Construction Division
Additions & Alteration Charges Approval Form

Quality Control Check Report. Stage: After Finishing Stage III (Apartments)

GULMOHAR RESIDENCY

Details of Additions & Alterations

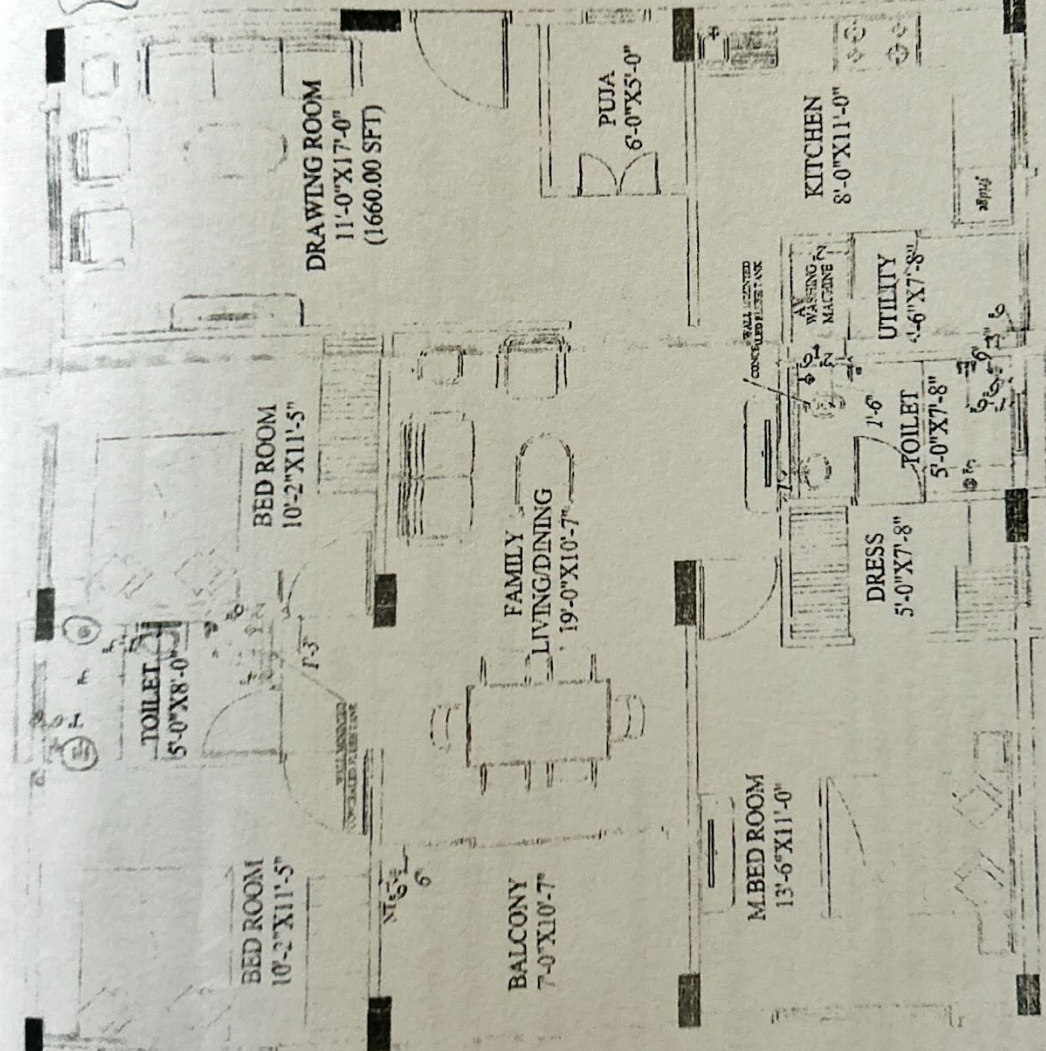
S No	Room	Civil work near pipes in balcony & utility ⁷ (✓ or ✕)	CPVC & PVC Check ⁵ (✓ or ✕)	Electrical points check ⁶ (✓ or ✕)	Water proofing check ⁸ (✓ or ✕)	Proper use of fasteners check ⁹ (✓ or ✕)	Placement of DB ¹⁰ (✓ or ✕)	Placement of Generator changeover (✓ or ✕)
1	Bedroom 1 M. Bed	—	—	✓	—	—	—	—
2	Toilet 1 M. Toi	—	✕	—	✕	✓	—	—
3	Bedroom 2 G. Bed	—	—	✓	—	—	—	—
4	Toilet 2 C. Toi	—	✕	✓	✕	✓	—	—
5	Bedroom 3 K. Bed	—	—	✓	—	—	—	—
6	Toilet 3	—	—	—	—	—	—	—
7	Drawing	—	—	✓	—	—	✓	—
8	Dining	—	—	✓	—	—	—	—
9	Lobby 1 Pooja	—	—	✓	—	—	—	—
10	Utility / balcony 1	✓	—	✓	—	—	—	—
11	Utility / balcony 2	✓	✓	✓	—	✓	—	—
12	Utility / balcony 3	—	—	✓	✕	✓	—	—
13	Kitchen	—	—	—	—	—	—	—
14	Other	—	✓	✓	—	—	—	—
15	Other	—	—	—	—	—	—	—
Remarks NOTE: - (1) Level marking was not provided. (2) Shower and Geyser angle corks was not provided at specified height in M. Toi & C. Toi & also end plug are missing.								
Remarks on additions & alteration sheet: (3) In/for change the Geyser & shower places at C. Toi not as per Drawing

Screeding done on walls upto 12" outside bathroom/utility	☐ Yes	☒ No
Bathroom /utility filled with 4" water for water proof check	☐ Yes	☒ No
Hole packing done around all pipes in ceiling and internal walls	☒ Yes	☐ No
Remarks: NOTE: - 1) Screeding was not done in M-Toi, c-toi & utility.

Description	Direction	Owners & Developers :	Date :	Promoted by
	N	Modi Reality Mallapur LLP	Prepared By :	Modi Properties Pvt Ltd
		Project Name & Phase :	Approved By :	Soham Modi
		Gulmohar Residency	Scale :	N.T.S
		WORKING PLAN-1660 SR-B1 TYPE

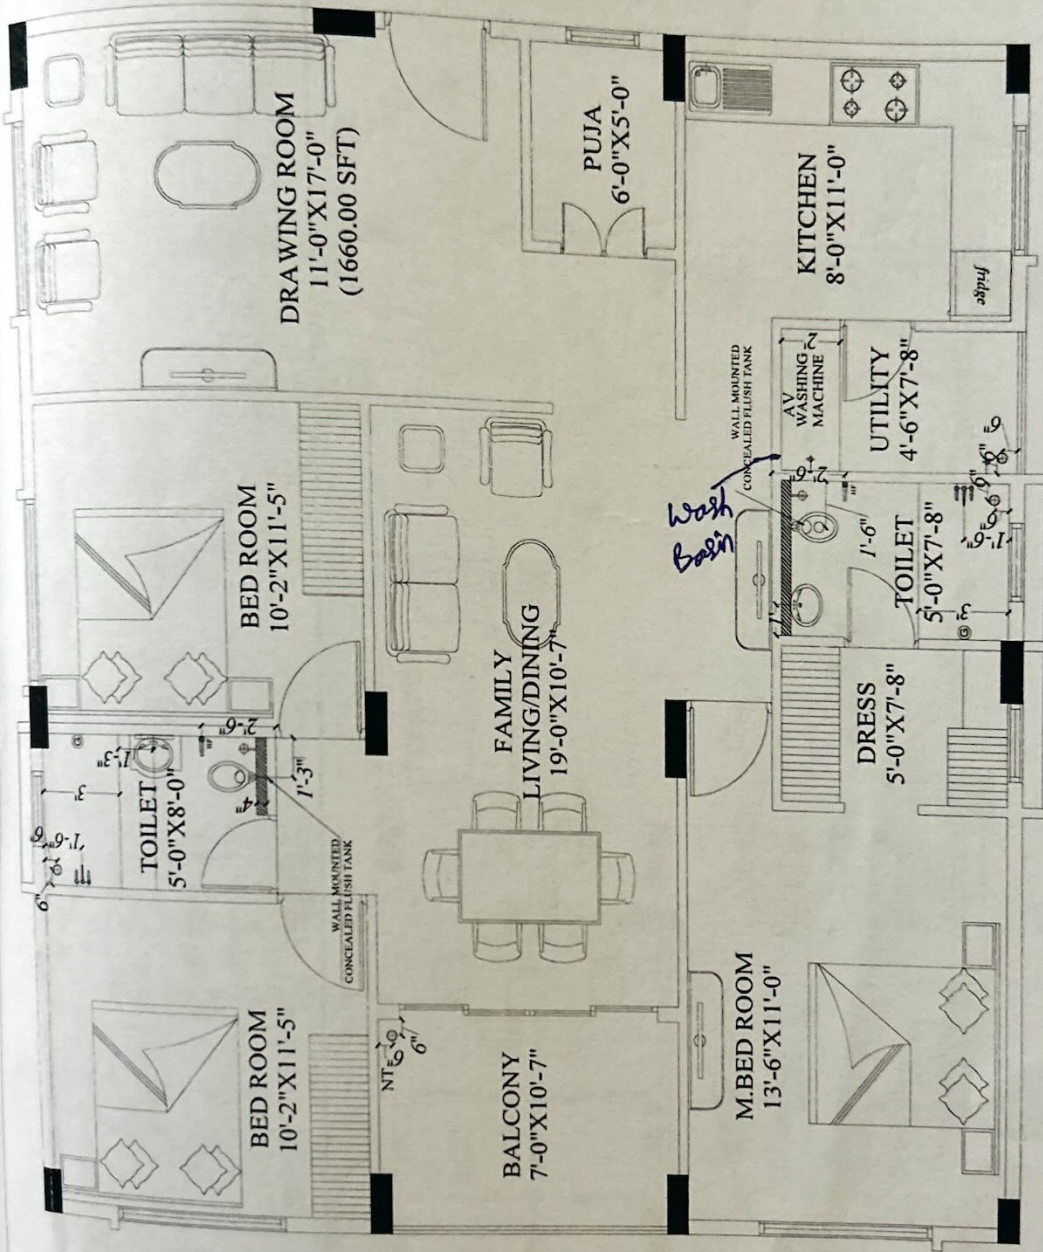
- 1) Exhaust hole - 6" in Both Bathrooms.
- 2) Wash basin in Hall as per Drawing
- 3) Utility wall 4' as per Drawing.

Description	Direction N 	Owners & Developers :		Date :	Promoted by	
		Modi Reality Mallapur LLP		Prepared By :	23.09.2020	
		Project Name & Phase :		Approved By :	Jayapradha	
		Gulmohar Residency		Scale :	Soham Modi	
					N.T.S	
ELECTRICAL PLAN -B1 TYPE-1660 sft		Phone: +91-40-66335551

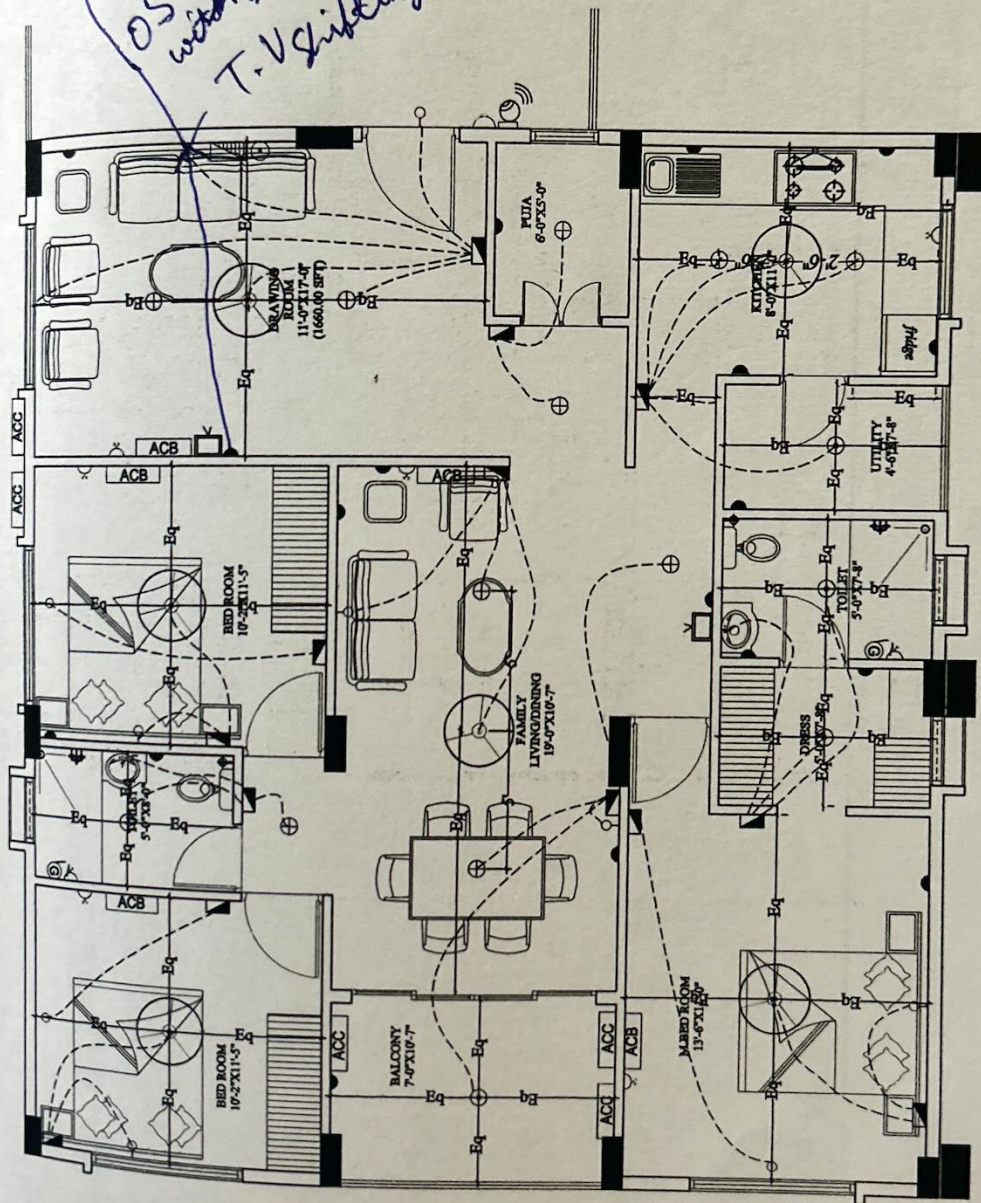
1) Extra 05 Amps Socket & Switch - 05 nos
as per Drawing.

OS nos Extra
OS Amps
with switches
T.V. Sighting
